Rezoning Transportation Analysis

Petition Number: 2018-049

General Location Identifier: 08312620, 08312619, 08312601, 08312608

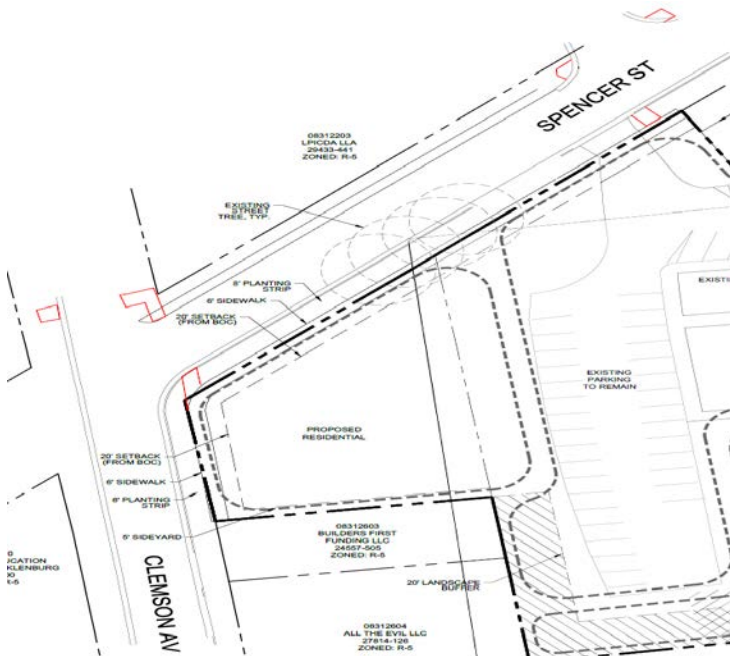
- ~~4. The petitioner should revise the site plan and conditional notes to show curb ramps at the intersection of Spencer Street and Clemson Avenue and the intersection of East 34th Street and Spencer Street as shown below:~~
